# MEMORANDUM

SUBJECT: Site Plan Approval – 1067 Marble Street, VL-1 Marble Street and VL-8 Water Street

DATE: December 28, 2023

Re: Site Plan Approval – Hale Transportation Building Addition

REVISIONS		
NUMBER	DESCRIPTION	DATE
1	CITY OF WATERTOWN COMMENTS - REVISED TREE SPECIES TO INCREASE DIVERSITY	12-18-2023

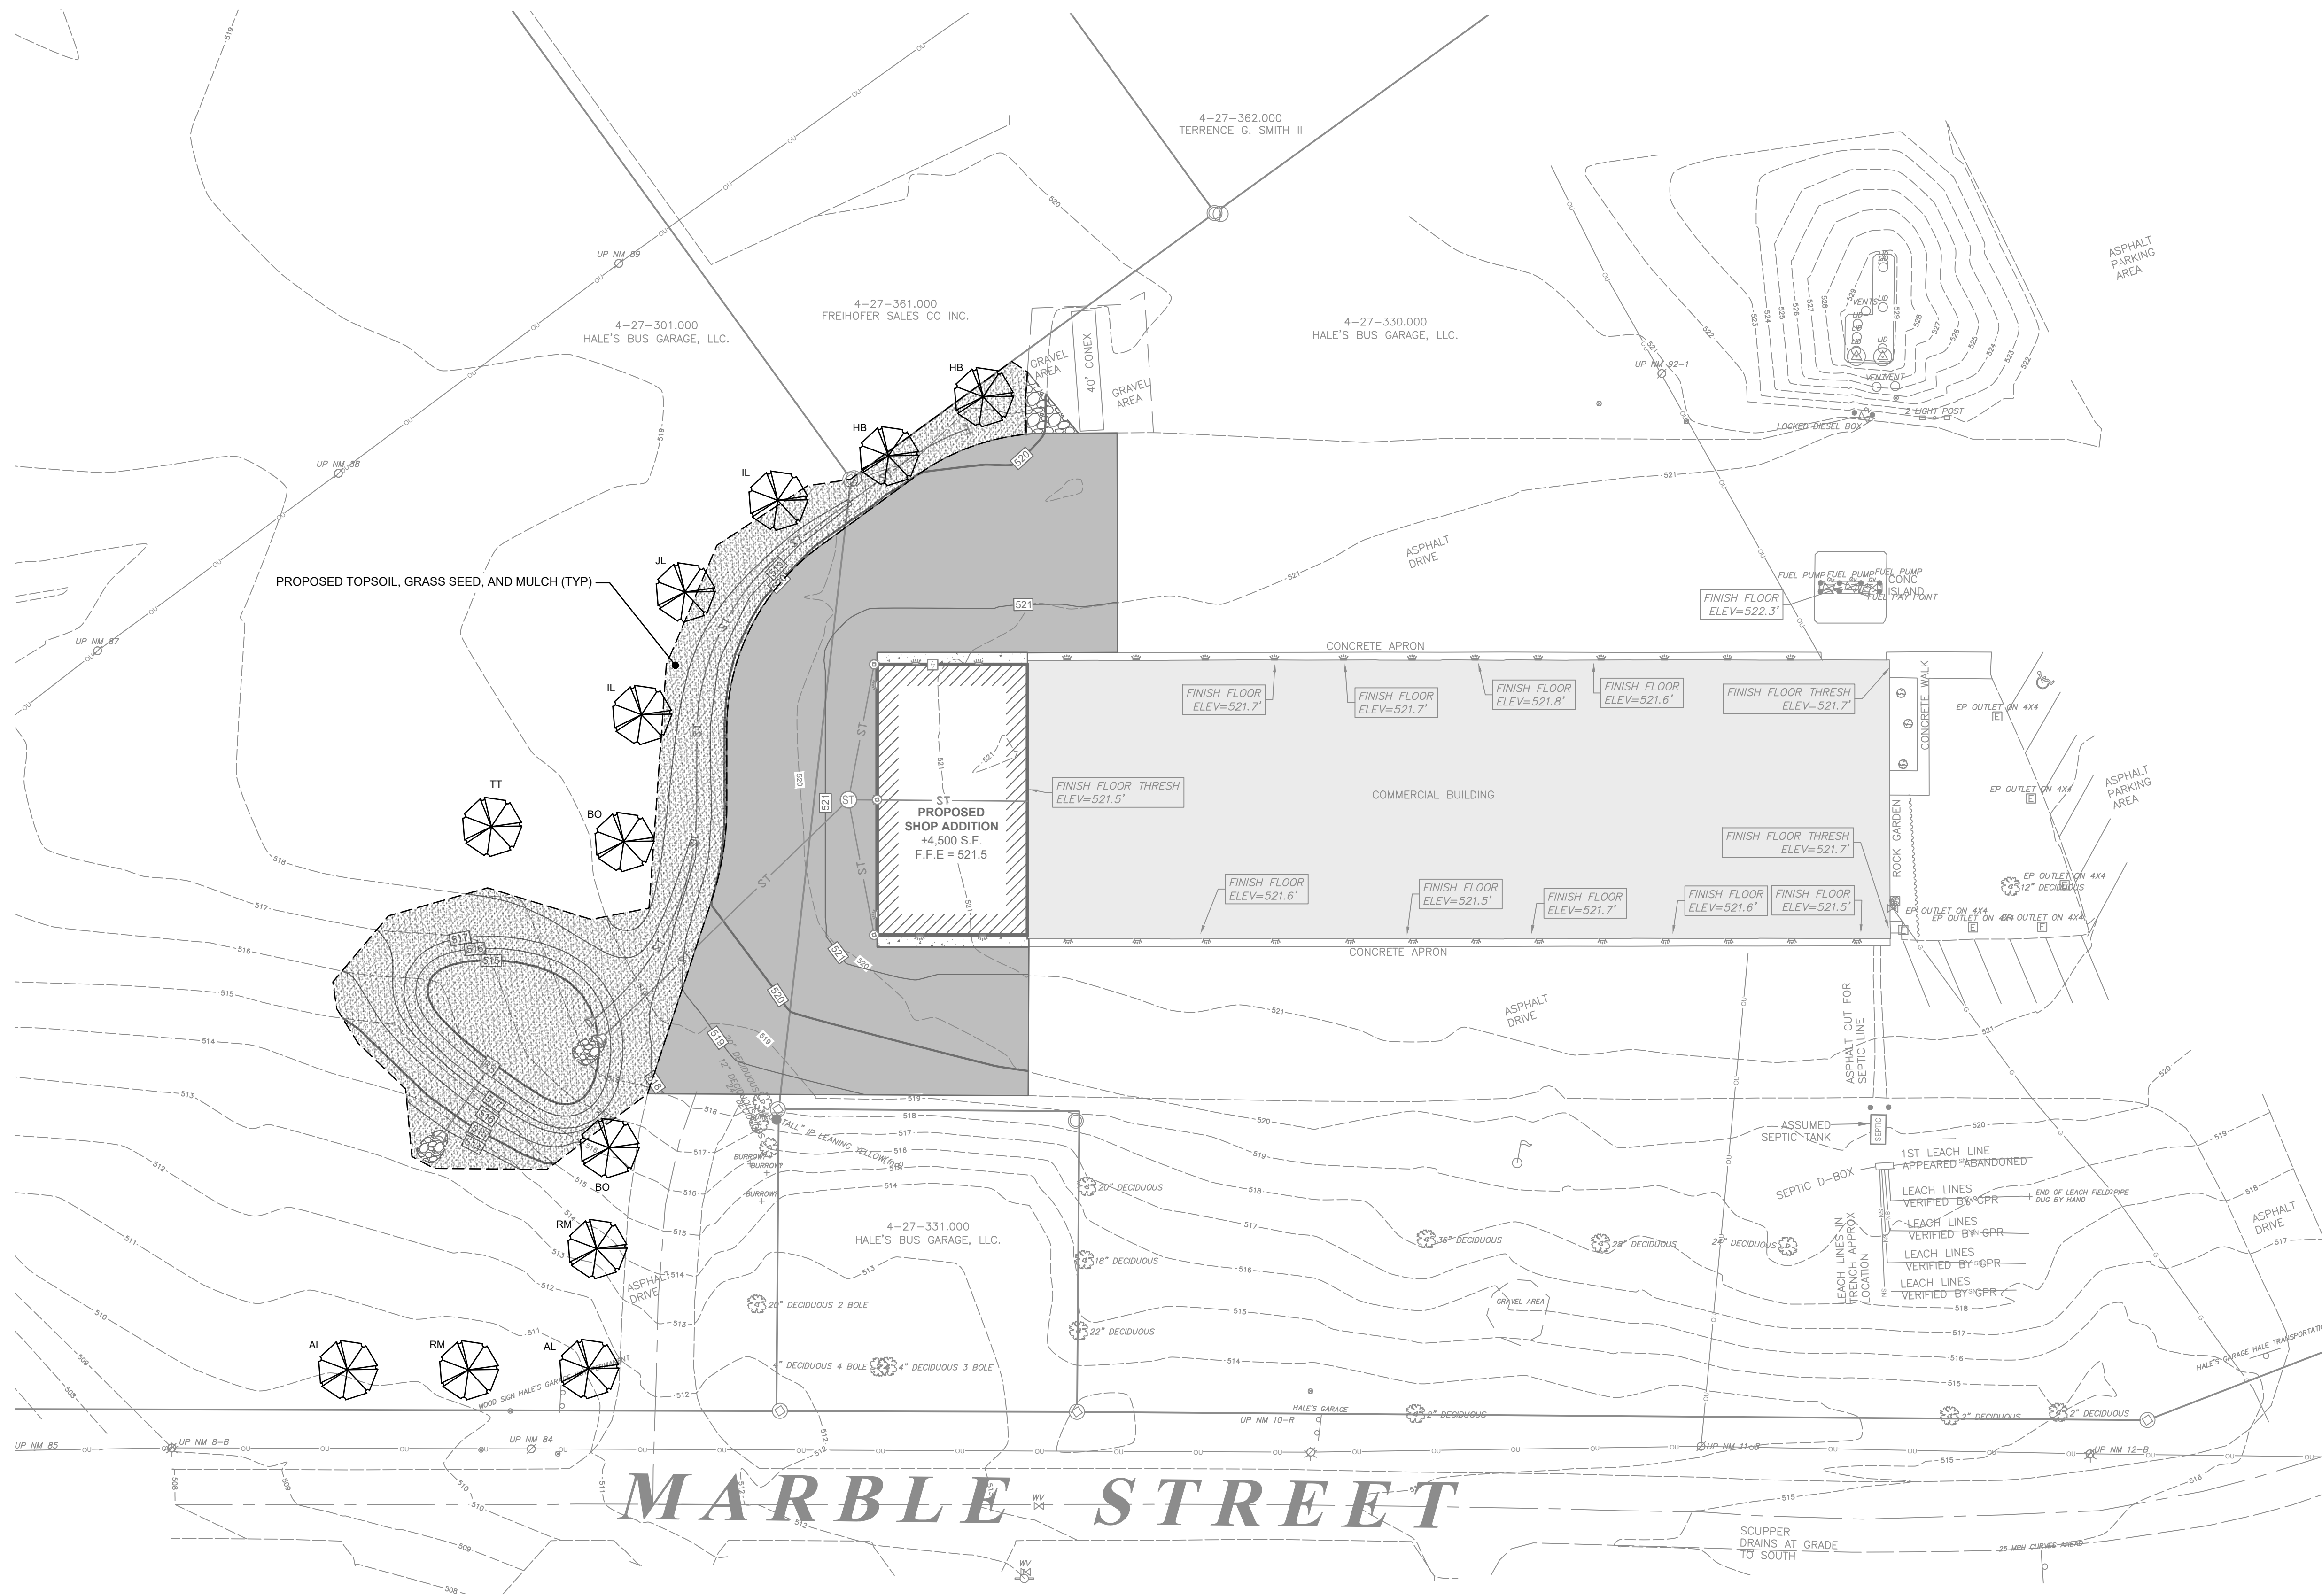
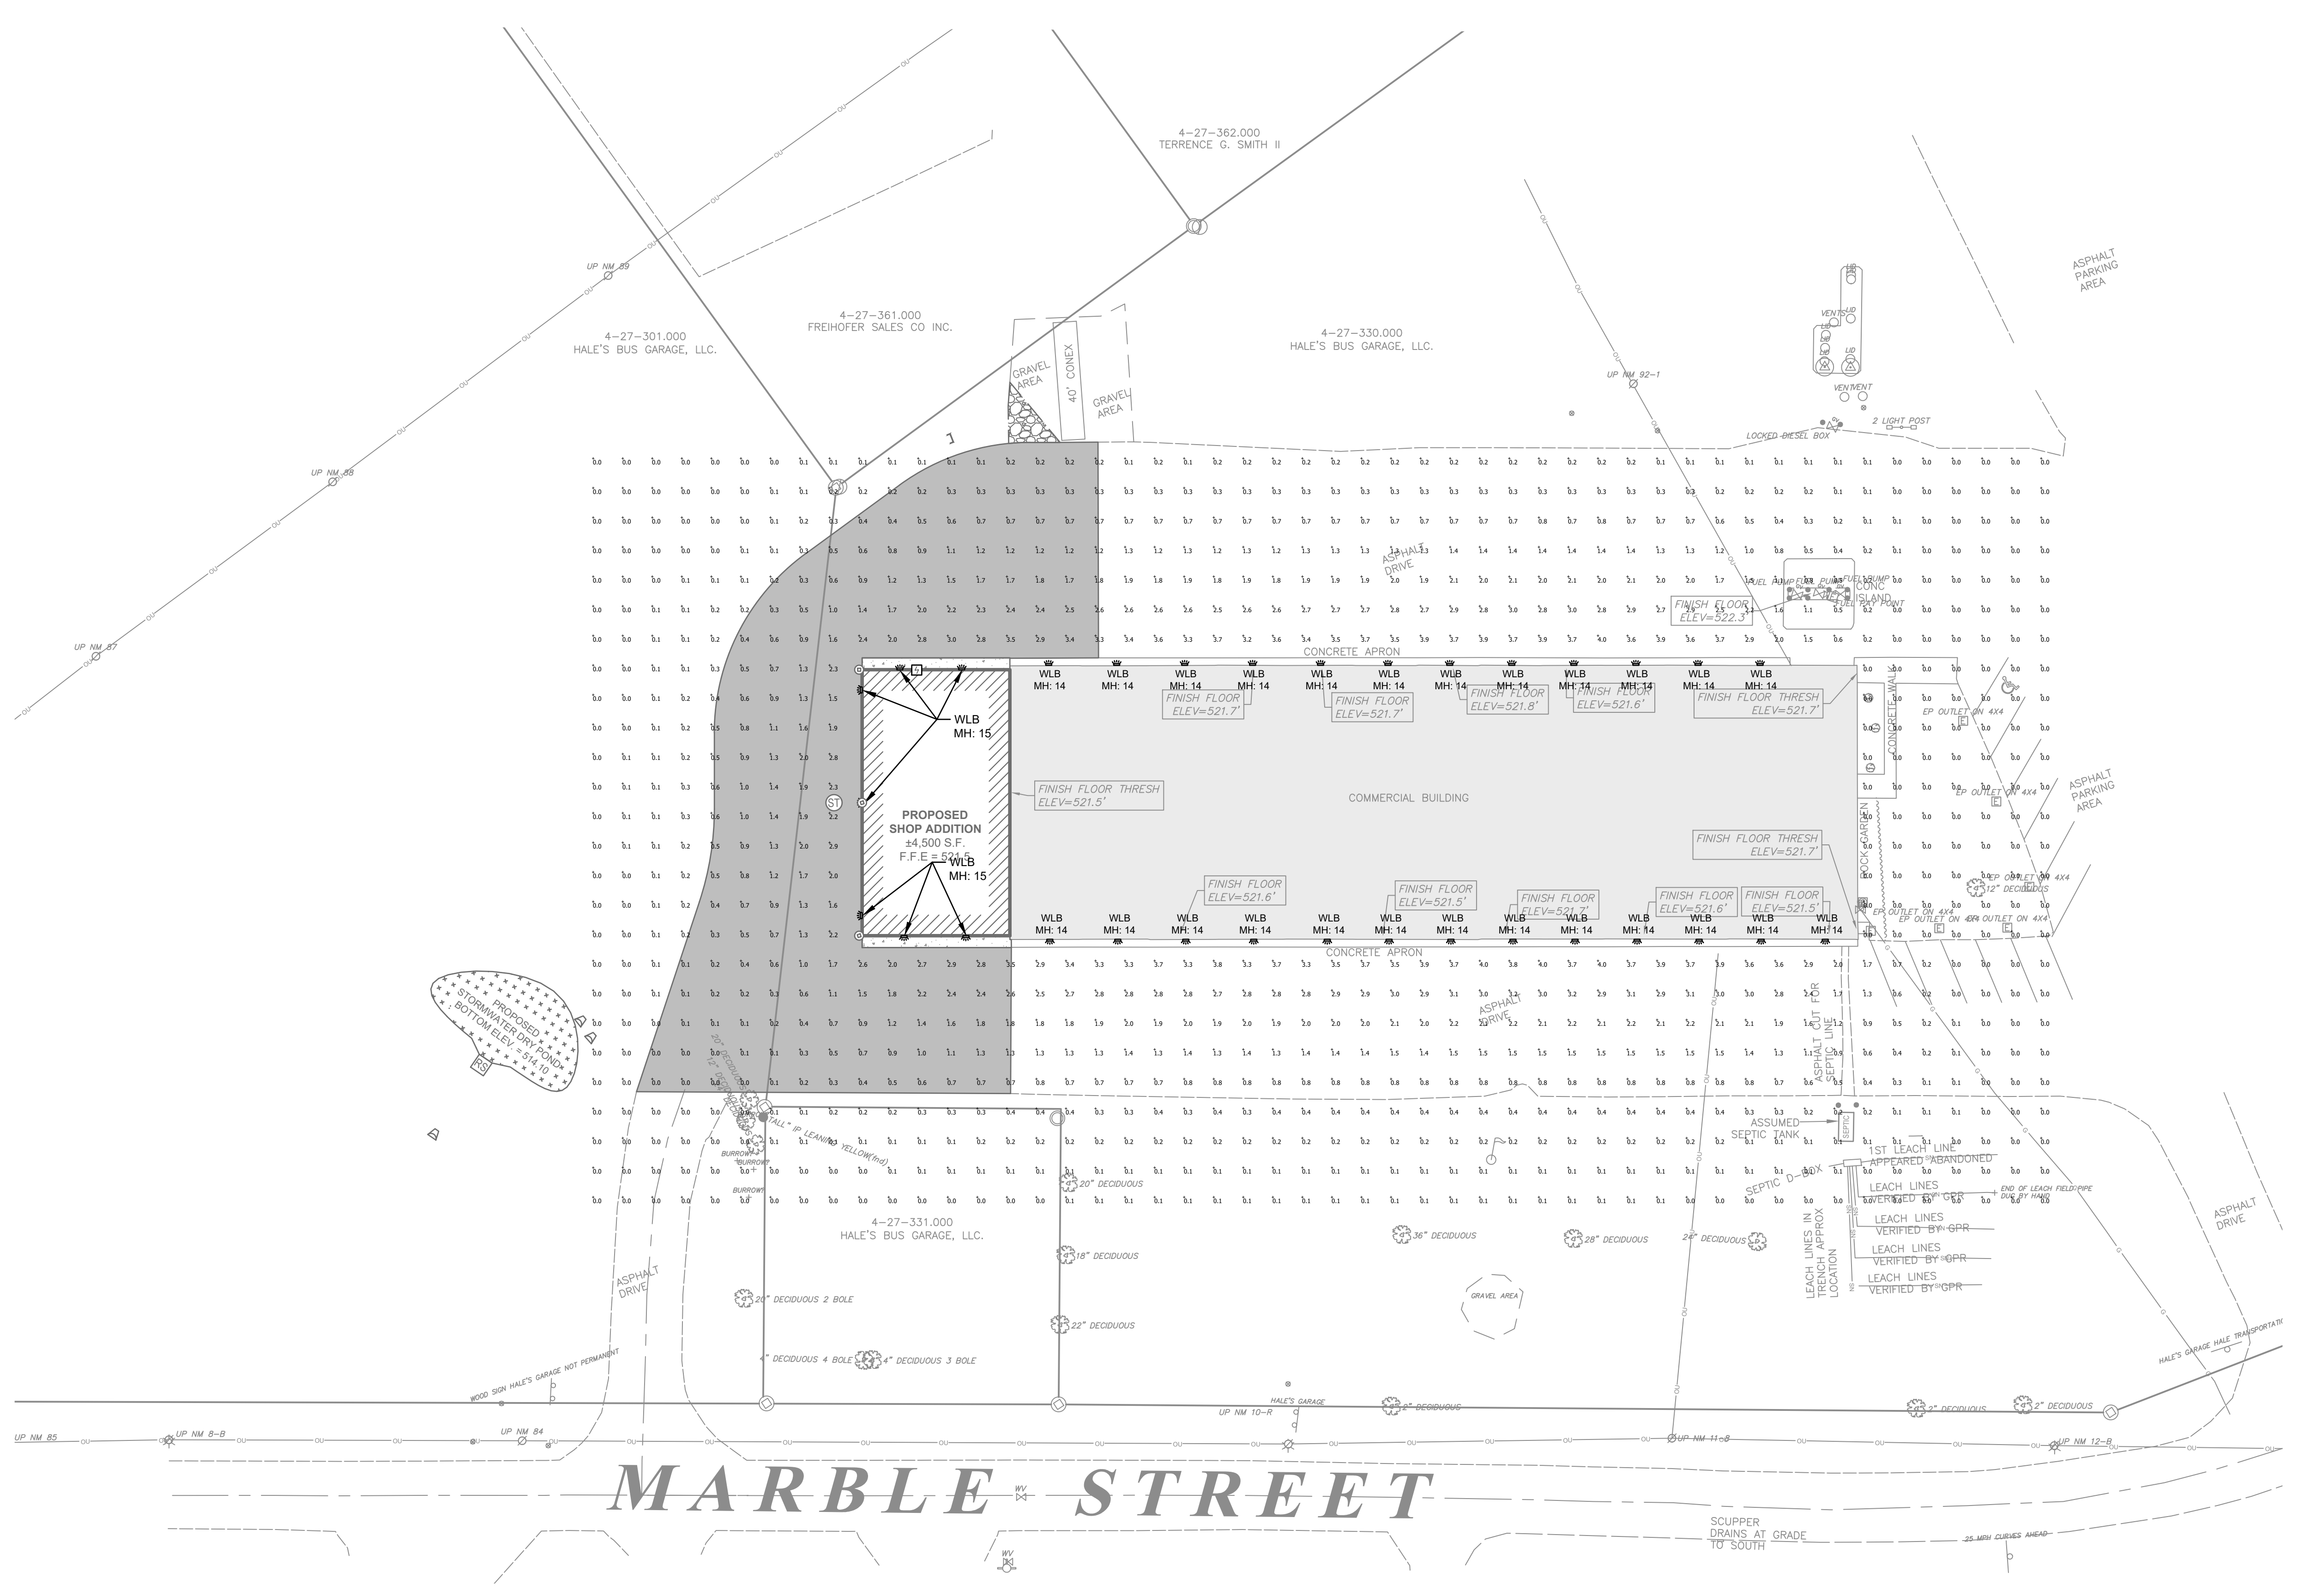
7. The applicant shall diversify the tree species in the planting schedule to a minimum of seven (7) distinct species so that no individual species makes up more than 15 percent of the planting schedule and work with Staff to identify and confirm appropriate species and locations. *This item is satisfied. The applicant has revised the landscaping plan to include seven distinct species, including several species recommended by Staff.*

Currently, the applicant only proposes three different tree species on the Landscaping Plan; *Acer rubrum* (red maple), *Celtis occidentalis* (hackberry), and *Liriodendron tulipifera* (tulip tree). The applicant shall work with Staff to select four (4) additional site-appropriate tree species to diversify the planting schedule as well as selecting the most optimal locations for each species.

Although Red Maple and Hackberry can tolerate varying degrees of soil compaction, Tuliptrees do not tolerate compacted soils well. In the submitted Landscaping Plan, the applicant identifies a Red Maple and Tuliptree immediately and adjacent to the retention pond. Although Red Maple generally displays a moderate tolerance to soil compaction, the applicant currently anticipates compaction levels up to or exceeding 90 percent for areas 25-to-35 feet west of the paved asphalt parking. 90 percent compaction is not suitable for planting trees. Although that level of compaction may be necessary to secure underground structures and to achieve proper grading, trees should be planted in areas that receive a maximum compaction rate of 80-to-85 percent. Therefore, Staff does not recommend planting trees within the limits of disturbance. Trees should be planted west of the silt fencing and outside all disturbed areas as shown on the proposed plans.

Selecting appropriate planting sites and species will significantly improve long-term survival rates, as well as minimize future costs associated with tree removal and replacement as required by the City's Zoning Ordinance. To assist the applicant in selecting compaction tolerant species, the City has provided the following abbreviated list of species exhibiting higher success rates when planted in and adjacent to compacted soil: *Acer rubrum*, *Celtis occidentalis*, *Gleditsia triacanthos var. inermis*, *Platanus x acerifolia* 'Exclamation', *Quercus bicolor*, *Quercus macrocarpa*, *Taxodium distichum*, *Tilia americana*.

7. The applicant shall diversify the tree species in the planting schedule to a minimum of seven (7) distinct species so that no individual species makes up more than 15 percent of the planting schedule and work with Staff to identify and confirm appropriate species and locations.
  - a. **The planting schedule has been revised to diversify the species. Trees that were able to be relocated to outside the area of disturbance to avoid impacts from compacted fill materials have been moved. Note that some trees were unable to be relocated outside the area of disturbance, however a note has been added to detail 4/C503 to specify a maximum of 80% - 85% compaction in tree planting areas.**
